Construction of Remote Park & Ride Facility, Land to the North-West of the A41, Bicester, Oxfordshire

Statement of Community Involvement

October 2013

Drawing title
 STAKEHOLDER CONSULTATION EVENT 1
 DISCUSSION DRAWING

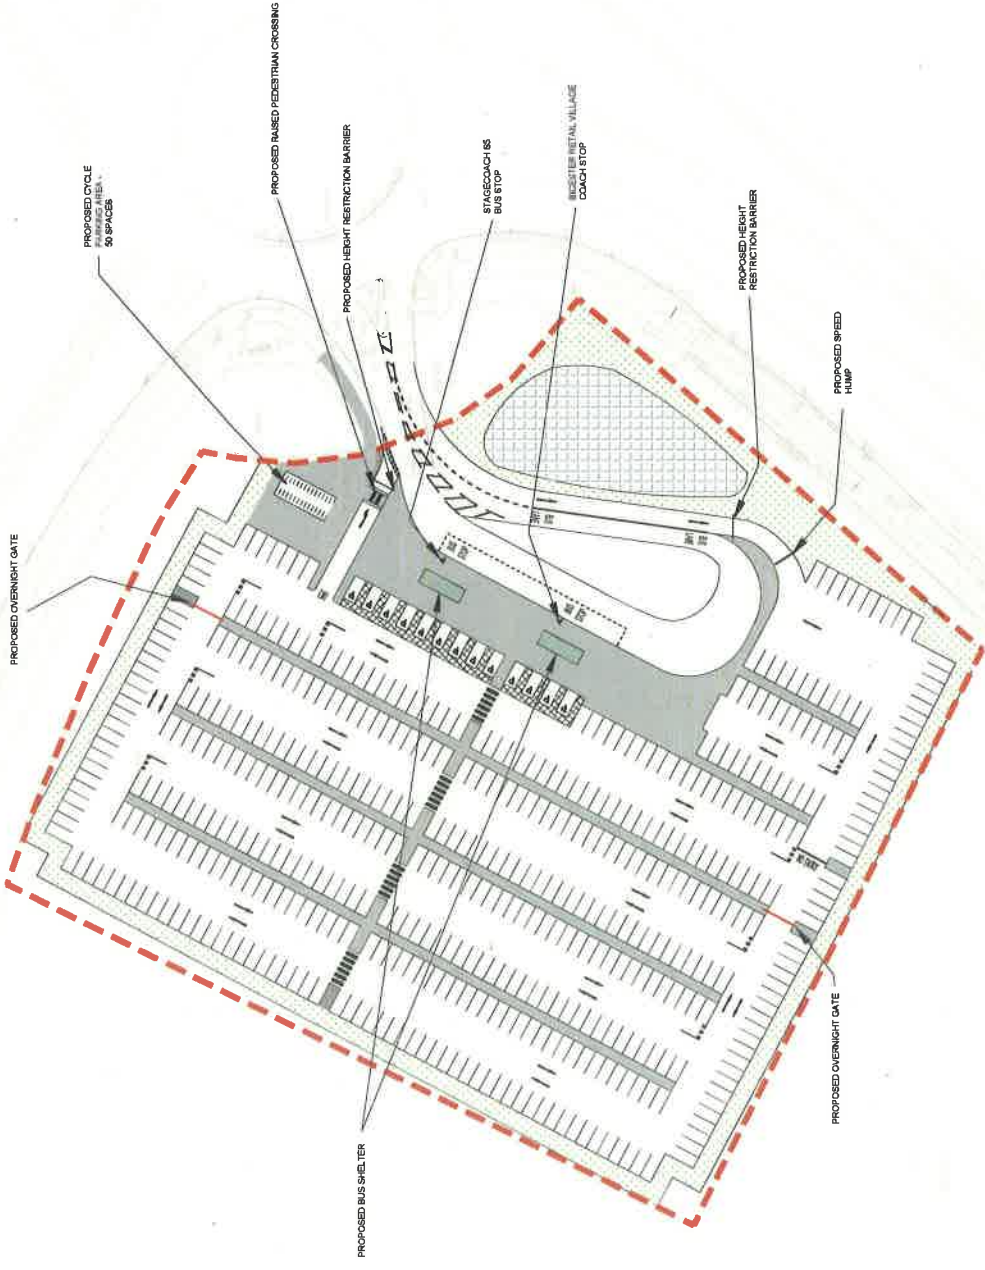
- Need to include 'Parent and Child' spaces – these are included at other P&R locations within Oxfordshire, e.g. Thornhill. These could be combined with the disabled spaces, e.g. designated disabled spaces, designated parent and child spaces and disabled or parent and child spaces. Need to consider including motorbike parking spaces. *To be amended in the final design. In respect of parent and child spaces, OCC have recently removed these spaces from the Thornhill Park and Ride due to the difficulties of enforcement and abuse.*

- Agreed that there was no current need to provide for electric vehicle charging spaces. *No action required.*
- Shelter length is to be increased as it was felt that the shelter should run along the whole length of the waiting area and should also run alongside the frontage of the waiting area. *To be amended in the final design.*

- The shelters should have backs to them to protect passengers from wind and rain Disabled access must also be taken into consideration when designing the protective shelter backs. *To be amended in the final design.*

- Seating should be provided in the bus shelters – this should be perched seating to ensure that it is not used for sleeping etc. *To be amended in the final design.*

- Requested that changes are made to the walkways – 2 wider vertical walkways should be provided and the linear walkways removed. This would free up more space for parking and provide better, more attractive and direct walkways for users. *To be amended in the final design.*

- It was suggested that an average of 5 LUX lighting would be quite low for a car park and should be revisited. The colour of the lighting also needs to be considered to ensure that the lighting feels warm and safe and not cold. *The 5 LUX is an average across the site, the LUX levels on site vary from between 1 LUX and 20 LUX but the average is 5 LUX. The colour of the lighting will be considered as part of the lighting scheme for the Site. Further discussions to be undertaken between Atkins and OCC Street Lighting to ensure that the overall scheme is acceptable.*
- The attenuation pond would need to include some edge planting to ensure that access to it is restricted. *To be annotated as part of the final design. The planting specifics would be subject to a detailed landscaping scheme which it is expected could be a condition of the planning consent.*

- Clarification was sought on the surface materials to be used to ensure adequate drainage – parking spaces should be constructed using a porous material such as gravel. Gravel may result in long term maintenance issues. Porous tarmac would be difficult to clean. Porous block paving would be more expensive to install but would cost less to maintain over the longer term. *Consideration to be given to the specific material to be used but surface materials will be porous. The proposed attenuation pond has been designed for a 1:100 year storm plus 30% and would be 1m deep. This is not large enough to fully attenuate the site and therefore porous surfaces are required on Site to attenuate the remaining surface water. A permeable block paving system is being considered for the Scheme (e.g. a product supplied by Marshalls). The porous sub-base of the block paving system will be used as part of the storage volume.*

- Clarification was sought on the details of the proposed attenuation pond and it was suggested that this could be extended onto the adjacent land to the north-east of the Site, should OCC have control over this land. It was suggested that the drainage ditch to the east of the Site along the A41 could be used as an overflow ditch, although it would need to be cleared and re-graded first. *This land cannot be used as OCC does not have control over the land. The use of the drainage ditch will be considered as part of the final design.*

- Does the proposed layout allow for additional bus services to use the P&R, should they wish to in the future? *The scheme has been designed to be as flexible as possible and space is provided for further bus services if necessary (3 in total). Any additions to the facility would be dealt with as necessary, through further planning applications at a later date. It should be noted that it would be difficult to physically provide more space for additional bus services without significant changes to the layout. The bus drop-off area is long enough for three 15m long coaches stopping at the same time.*

- Stagecoach may wish to store buses on the site overnight. This would mean the storage of up to 12 buses on site. They would prefer to store them at the front of the site rather than on the car parking area. It would not be possible in the current design to store all 12 buses at the front of the site. Storing buses at the rear of the site on the car parking area is likely to create issues in terms of maintenance of the car parking surface. This would also require the use of different construction methods in order for the car parking area to accommodate the extra vehicle weight. *Stagecoach to consider further and provide further feedback on whether they would like this requirement to be realised by end of September 2013. This will then be taken into account in the*

- Community Woodland is proposed to the north-west of the site, will access be provided to this from the rear of the P&R site? *A secondary, pedestrian only access to this land will to be considered in the final design. People wishing to use the woodland could use the P&R car park if they wished, although it is considered more appropriate for the woodland to provide its own*

- *Would it be appropriate to provide a separate pedestrian/cycle access from Vendee Drive, into the north-western corner of the P&R Site? This would allow pedestrians to walk through the Site rather than having to walk along Vendee Drive to the main pedestrian/cycle entrance? Although it is recognised that such a route may be informally used as a desire line by pedestrians and cyclists who may make their own route through the boundary planting, it is considered that this should be discouraged to prevent pedestrian/cyclist conflict with vehicles using the Site. The use of the formal pedestrian/cycle access into the Site (which brings pedestrians and cyclists directly to the cycle racks and bus shelters) should be encouraged as a primary option. Informal routes can be discouraged with planting. This area of landscaping is not highway land and is therefore outside OCC's control.*

- *Are the proposed overnight gates needed if buses are not stored on the car parking areas? Do we really need to close off parts of the car park? The need for these gates will largely be dependent on whether Stagecoach wishes to store buses on the rear of the Site at night. This will be determined prior to final design. OCC would like to be able to close off parts of the car park to direct parking to specific areas when the P&R is not being used to full capacity and therefore the overnight gates would assist in this purpose.*

Drawing title
**STAKEHOLDER CONSULTATION EVENT 2
 DISCUSSION DRAWING**

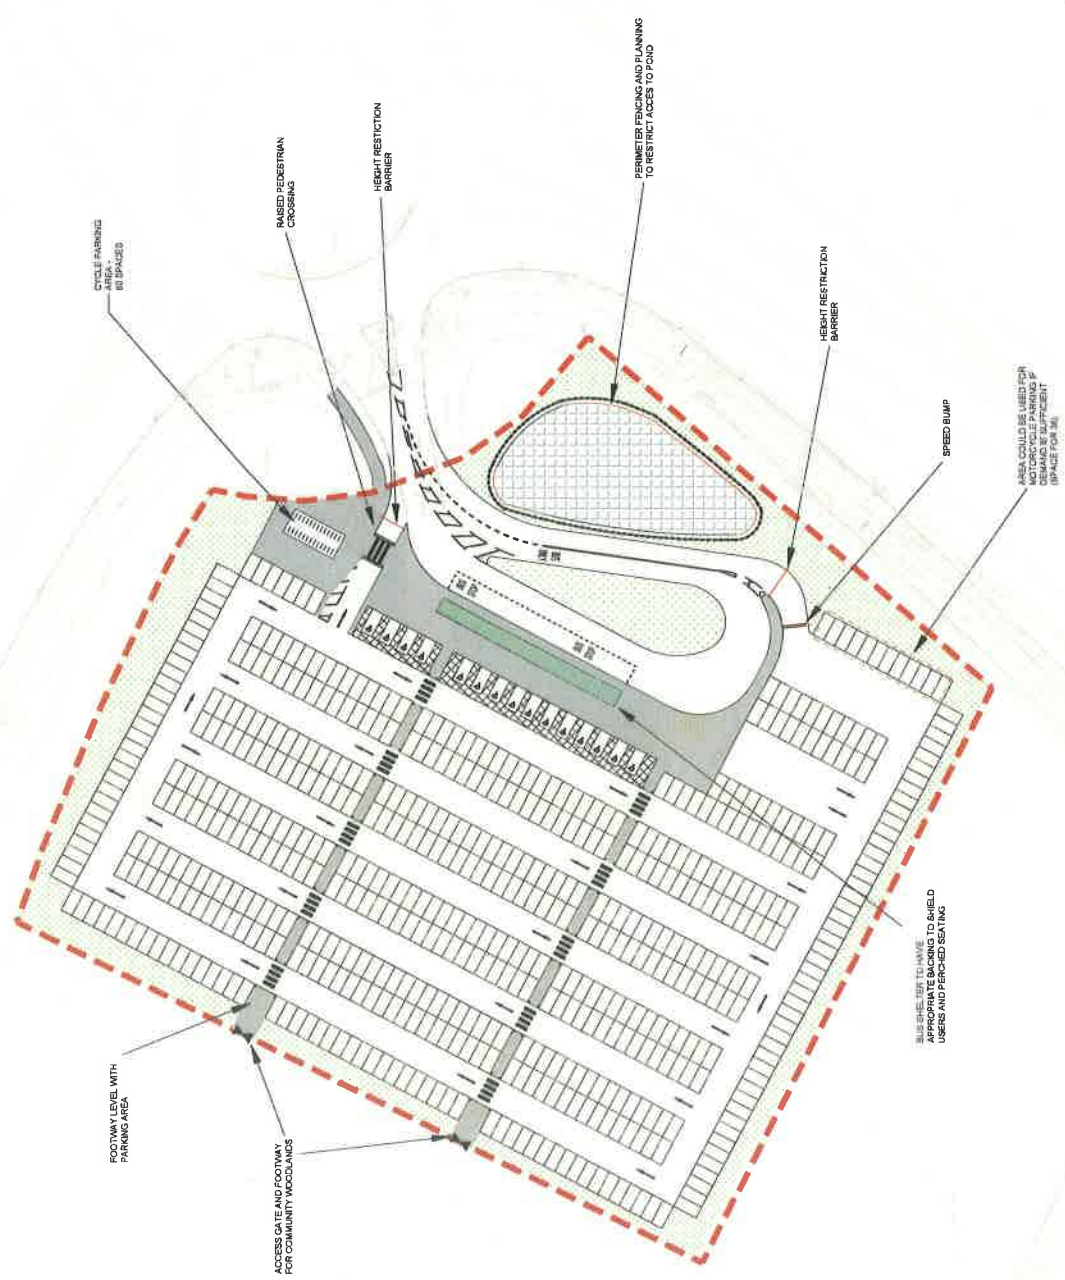
- Agreed that the car parking spaces should be 2.5m wide. These are much more accessible and efficient than 2.4m wide spaces given the nature of modern cars. Agreed that there should be no end islands in the car parking layout which will provide for 560 car parking spaces in total of which 15 spaces will be disabled spaces. *To be included in final scheme, no further changes necessary.*

- Agreed that covered walkways would not work on site as emergency vehicles could not pass under them and therefore their deletion from the scheme was considered to be acceptable. *Final scheme to show level, tactile colour contrasted flush walkways as these will provide a consistent and continuous walkway with no trip hazards. Strategically placed bollards will offer protection to pedestrians from vehicles.*

- The bus shelters shown are 3m wide, can these be widened to 4.5m wide to provide more protection to the elements? *To be amended in final design.*
- Can the current apron be widened with the bus stops moved westwards towards the car parking area, to enable a potential future expansion area on the central island? *An area in the central island will be provided for buses to lay-over (a place for buses to wait without picking up/dropping-off).*

- The design shown may not be the most efficient in allowing for 3 buses to pull in at the site one behind another, can a 'saw tooth' approach to the bus pull-in area be investigated? Could a 'run over' area be provided in the central island? *A 'saw tooth' approach has been investigated and this is not possible without removing all the car parking spaces in the south-eastern corner (approximately 50 spaces). Given the requirement from stakeholders to maximise the number of spaces within the design, whilst providing larger than standard spaces, removing more spaces is not deemed acceptable. A lay-over area will be provided.*

- A question was raised over whether the attenuation pond is needed? *Yes, this is required to attenuate the surface water run-off from the site and enable full attenuation.*

- Can surface water from the site be pumped across the A41? If a pump is required for the attenuation pond what are the costs of this likely to be and how would it work? *Pumping under the A41 would require significant highways works and would not be cost effective. The pond would need to be pumped which would itself be triggered by a float leveller. In terms of cost, it is likely that the annual maintenance costs for the pump would be £5-600 per year and the cost of a replacement pump (expected once every 25 years) would be circa £10,000.*

- General agreement on the key design changes made to the draft design as a result of the previous stakeholder workshops including 560 no. 2.5m spaces, removal of north - south pedestrian footways, amendments to east-west footways, removal of overnight gates and pedestrian access to proposed community woodland to the rear of the site. *No further action required.*

- What is proposed in terms of landscaping? *A circa 3m wide landscaping strip is to be retained and enhanced around the edges of the site which would be planted using native species. Sufficient land has been retained around the attenuation pond to allow this to be fenced and planted accordingly and to restrict access to the pond. It is expected that submission to OCC and its agreement of a detailed landscaping scheme would be a requirement of any planning consent.*
